SUBJECT: SUMMARY OF CONFERENCE CALL WITH PALISADES NUCLEAR PLANT
REGARDING THE SPRING 2017 STEAM GENERATOR INSPECTIONS (CAC
NO. MF9396)

CONFERENCE CALL SUMMARY
REGARDING PALISADES NUCLEAR PLANT
SPRING 2017 STEAM GENERATOR INSPECTIONS
DOCKET NO. 50-255
CAC NO. MF9396

**STEAM GENERATOR TUBE INSPECTION DISCUSSION DURING
PALISADES 2017 (RF25) OUTAGE (Preliminary Information)**

The following is the primary to secondary leak trend for the last fuel cycle

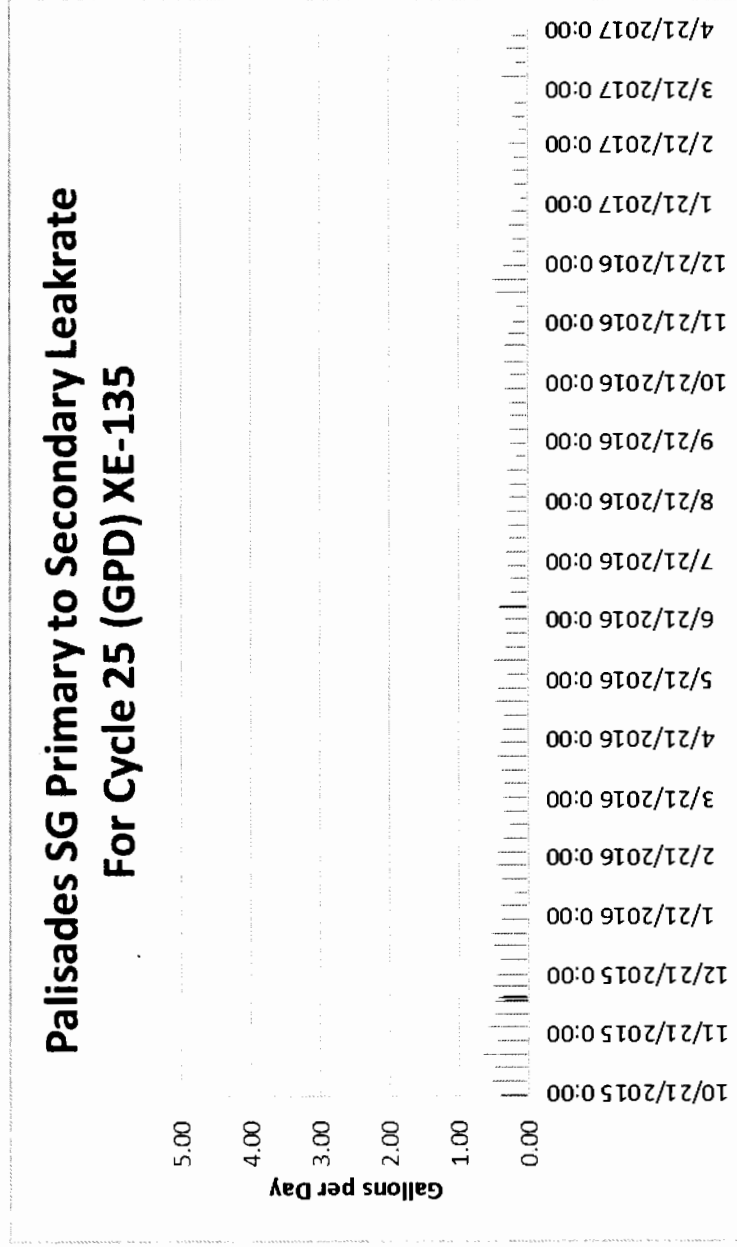
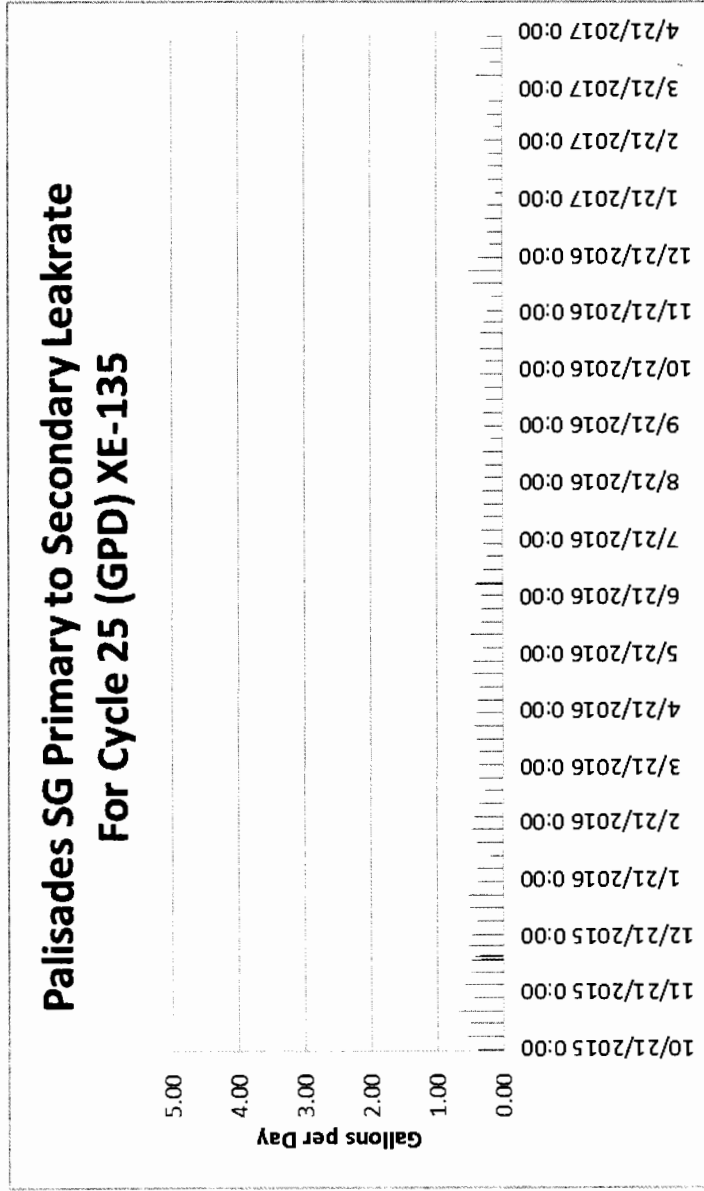
1. Discuss any trends in the amount of primary-to-secondary leakage observed during the recently completed cycle.

Refer to attached Primary to Secondary Leak Rate for Operational Cycle 25 Primary to Secondary Leak Rate graph. Leakage has been minimal all cycle.
